# Access Compliance Report

## Public Rights-of-Way

Intersection ID: 42486	Main Street: ALEXANDER MARTIN_AV	Cross Street: ALMA BLOUNT_BV	Location: NW
ADA ID: 2A01166946F1	Ramp Type: PerpDiag	Initial Pass/Fail: Fail	Overall Compliance: No
Severity Score: 12.5			
Codes/Mitigation Info/Possible Solution		Field Measurements/Component Compliance

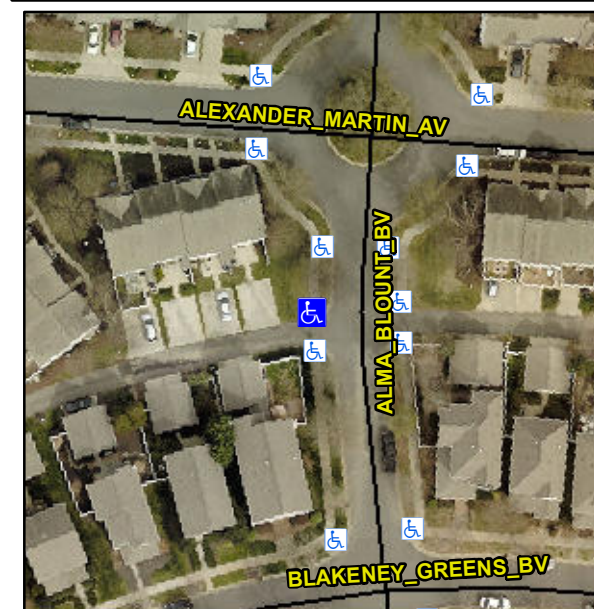
**R304.2.2**

Compliance	Description	Data	Compliance	Description	Data
N/A	Ramp Length (in)	86.0	No	Ramp Slope (%)	8.4
Yes	Ramp Width (in)	48.0	Yes	Ramp XSlope (%)	0.2
N/A	Flare Type LT	N/A	N/A	Flare Type RT	N/A
N/A	Flare Slope LT (%)	N/A	N/A	Flare Slope RT (%)	N/A
N/A	Flare Traversable LT?	N/A	N/A	Flare Traversable RT?	N/A
N/A	Landing Length (in)	N/A	N/A	DWS Provided?	N/A
N/A	Landing Width (in)	N/A	N/A	DWS Contrast?	N/A
N/A	Landing Slope (%)	N/A	N/A	DWS Length (in)	N/A
N/A	Landing X Slope (%)	N/A	N/A	DWS Full Width?	N/A
N/A	Landing Curb? (Y/N)	N/A	N/A	DWS Offset (in)	N/A
N/A	Shared Landing?	N/A			
N/A	Gutter Ponding?	N/A	N/A	Gutter Slope (%)	N/A
N/A	Gutter Lip Ht (in)	N/A	N/A	Gutter X Slope (%)	N/A
N/A	Painted X Walk1?	No	N/A	Painted X Walk2?	No
	X Walk 1 Direction	To S		X Walk 2 Direction	To E
N/A	X Walk 1 Width (in)	N/A	N/A	X Walk 2 Width (in)	N/A
	X Walk 1 Slope (%)	5.9		X Walk 2 Slope (%)	0.9
	X Walk 1 X Slope (%)	1.6		X Walk 2 X Slope (%)	4.6

**Remove & Replace Curb Ramp With Two New Directional Ramps or Equivalent.**
